A/E Firm: WRA Architects		PM Firm: CBRE Vanir JV	Date: 12-10-2025
Org #: 159	School Name: L.L. Hotchkiss Elementary School	Bid Pack #/ CSP#: 207325	Addendum #: 1

**DALLAS INDEPENDENT SCHOOL DISTRICT
PROCUREMENT SERVICES
ADDENDUM NO. 1
CSP 207325 – L.L. Hotchkiss Elementary School - Renovation**

The Purpose of this Addendum No. 1 is to provide an alternate bid and updated the drawings and specifications:

REVISIONS:	
No.	Date
1	Addendum #01 12/10/2025
JOB NO. 2239	
DATE: 06/11/2025	
Floor Plan Level 1 Overall	
A201

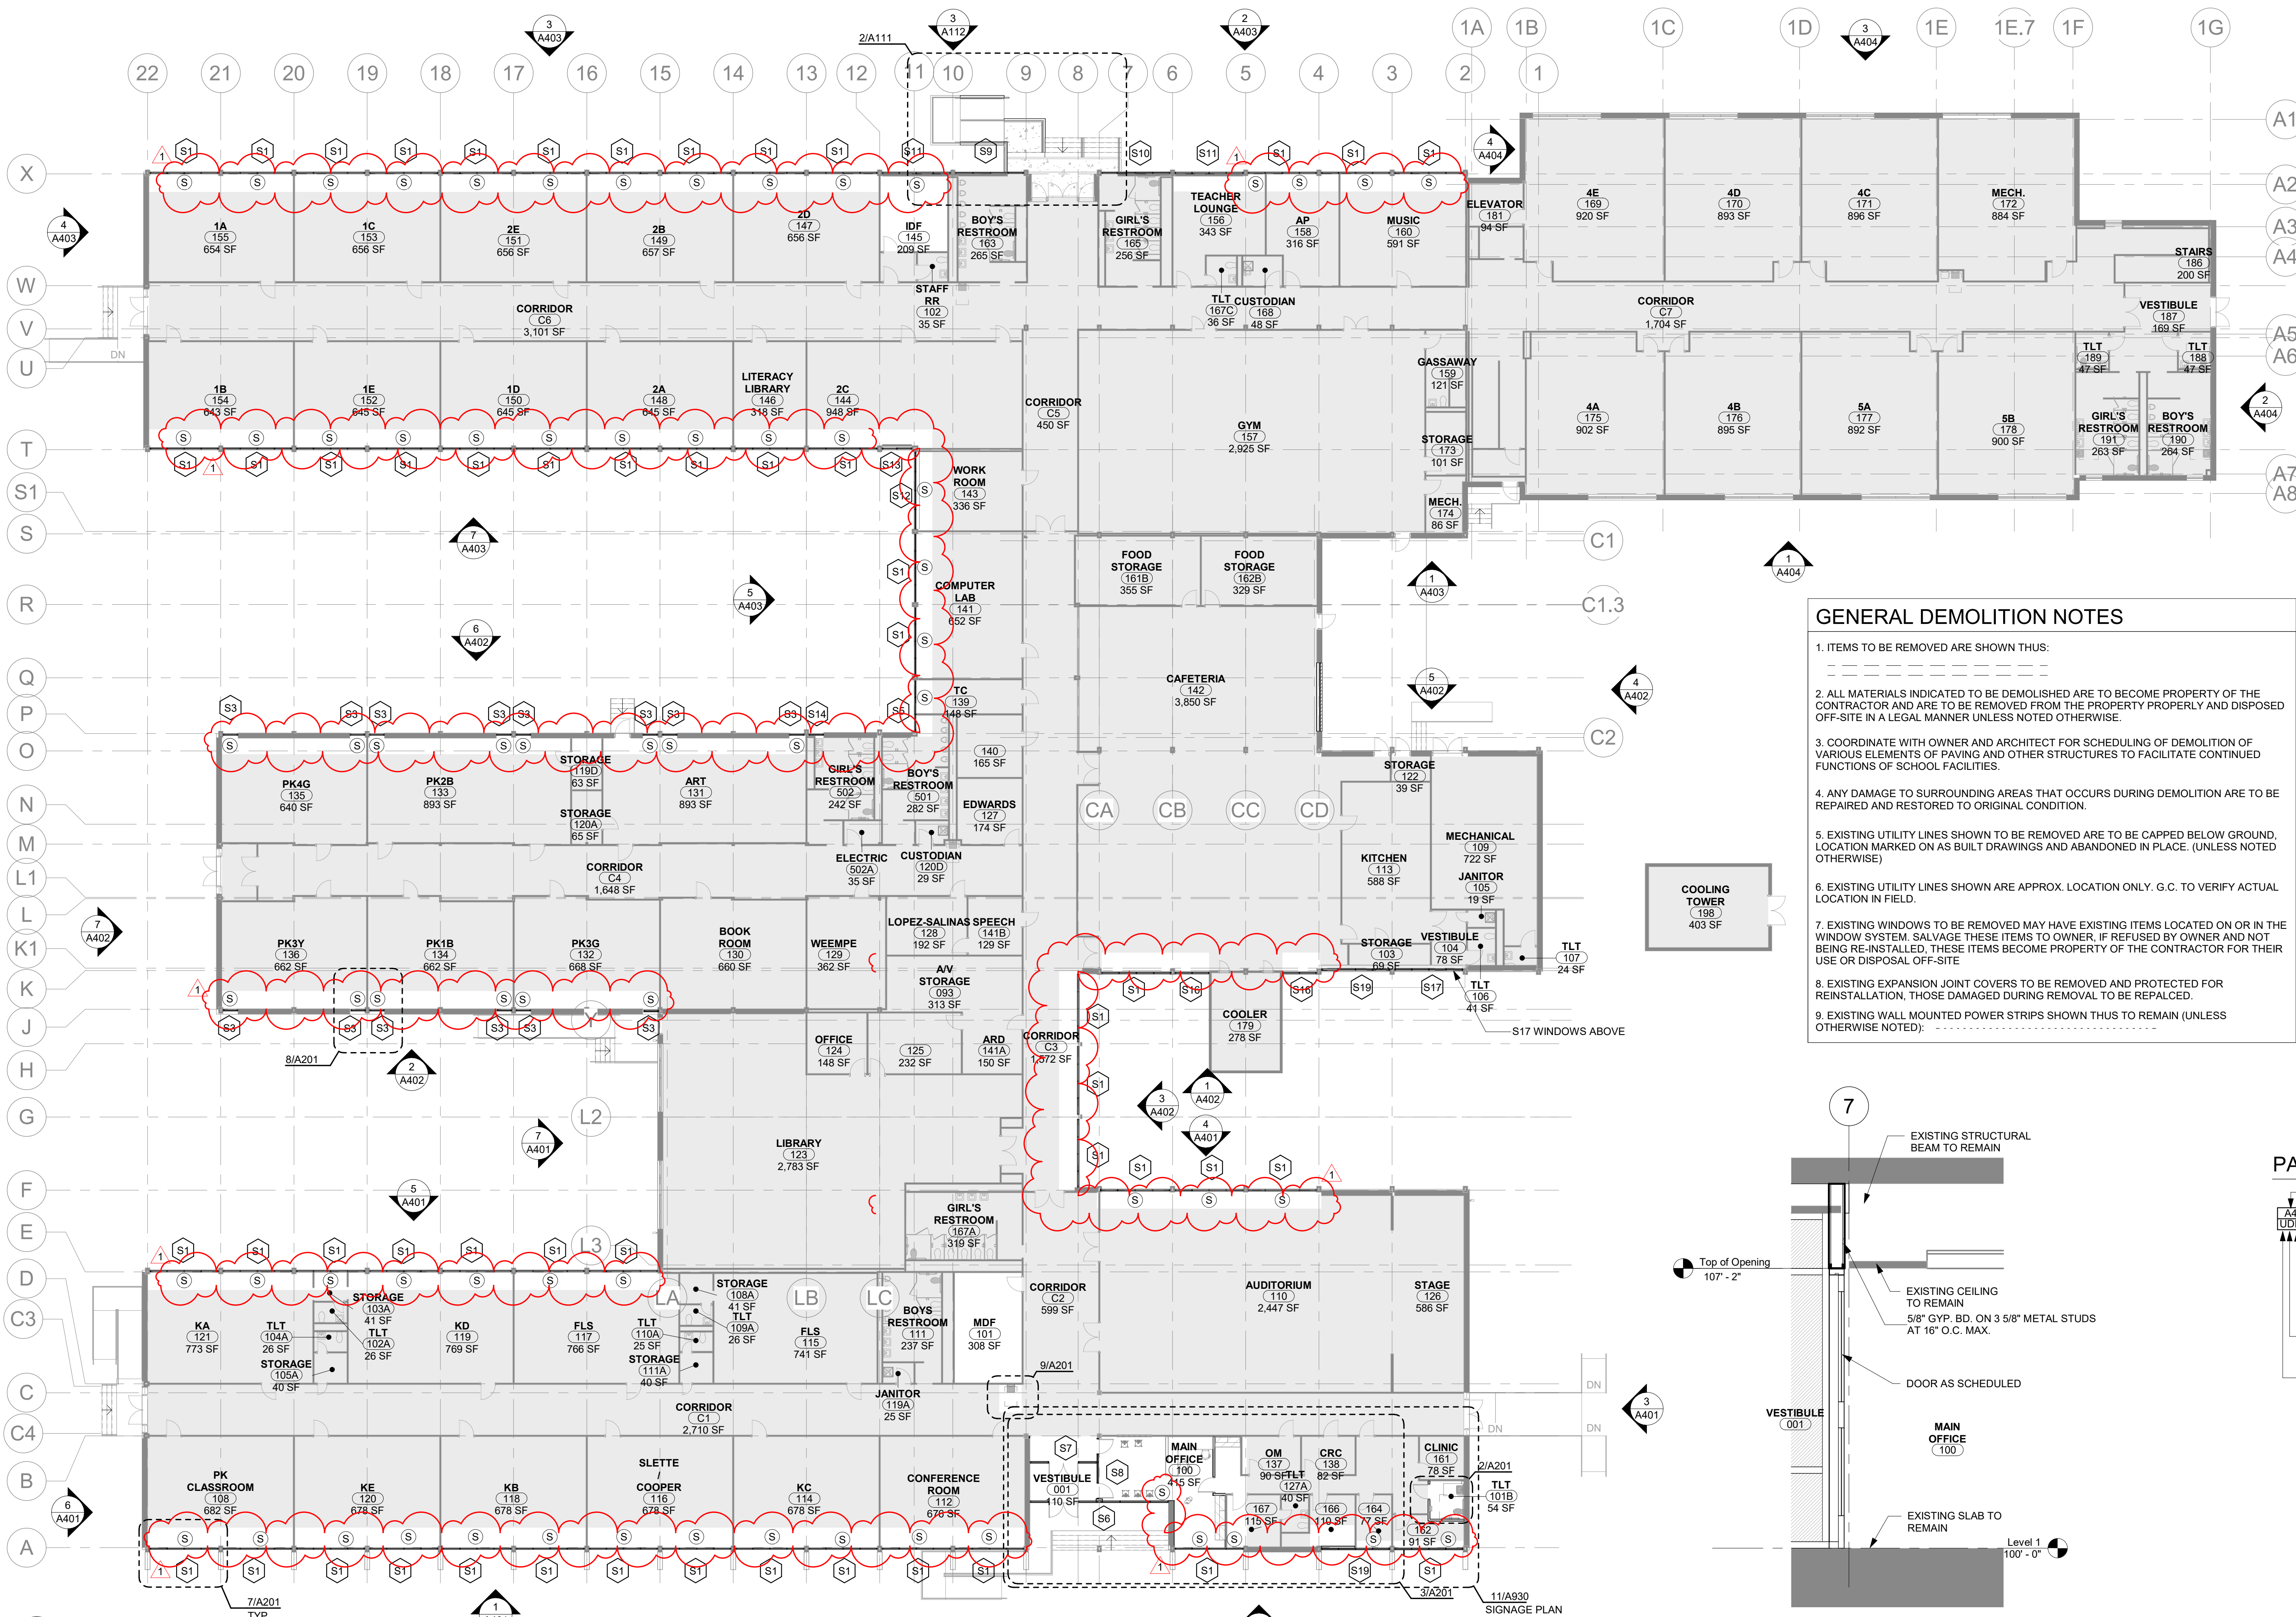
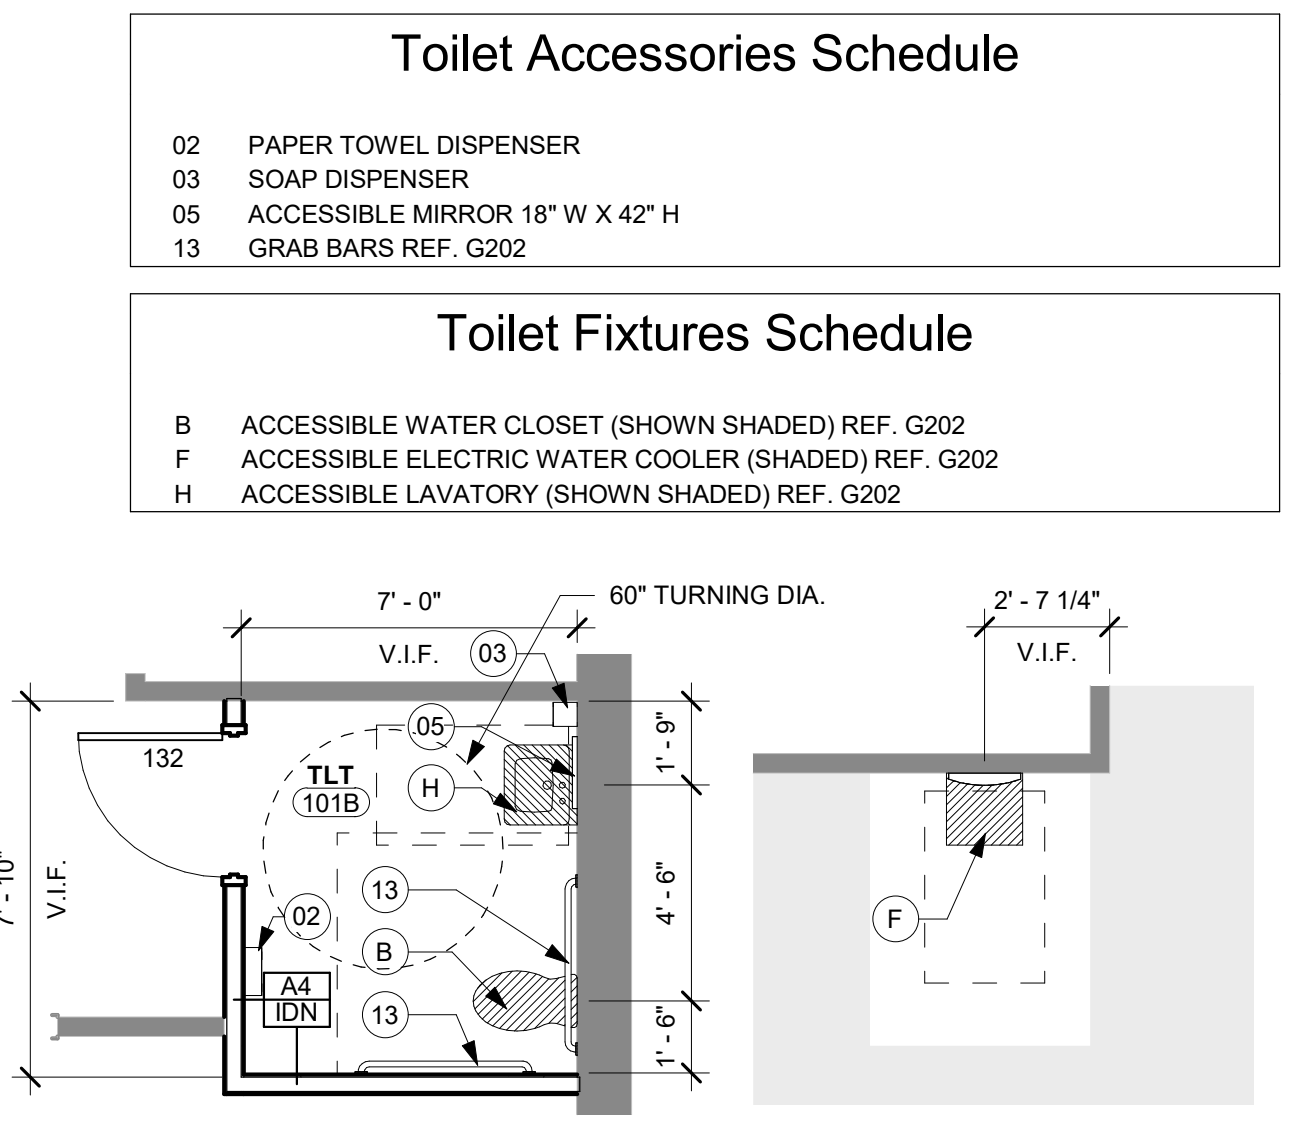
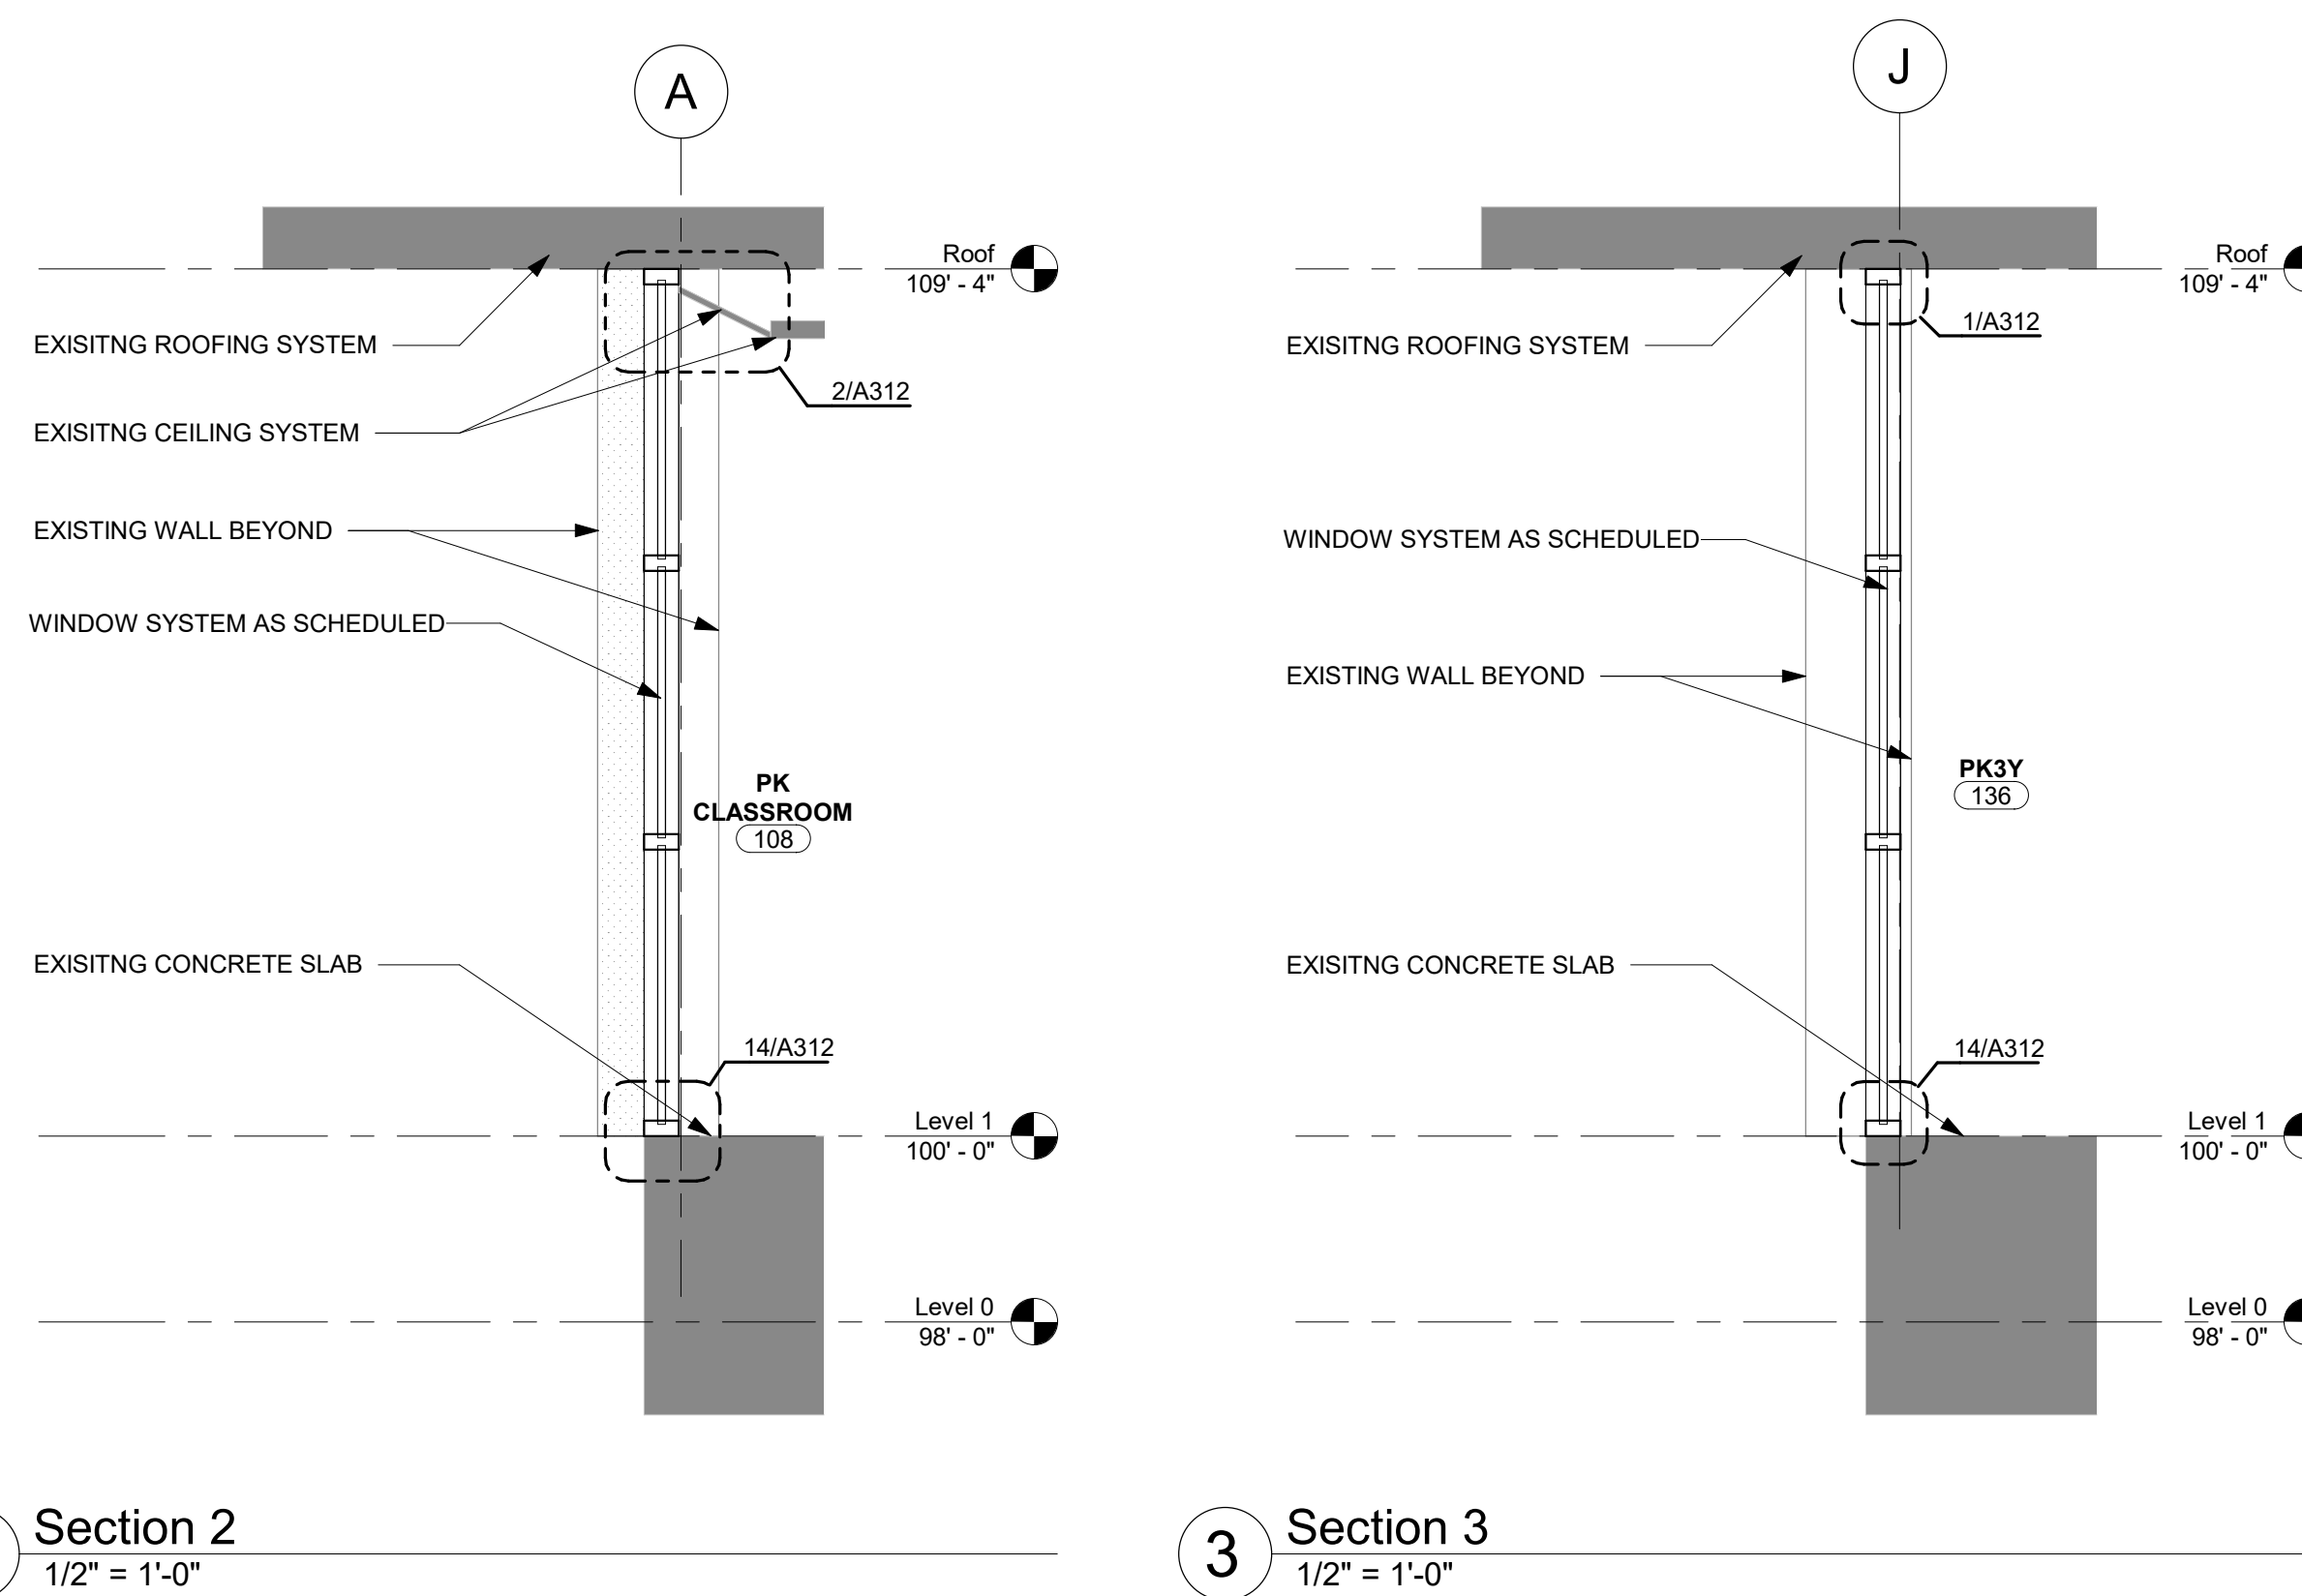
- A. Revised “FLOOR PLAN SYMBOLS LEGEND”
- B. Removed window blinds, Add window roller shades where clouded
- C. Removed all window blind in the corridors, auditorium, and cafeteria.
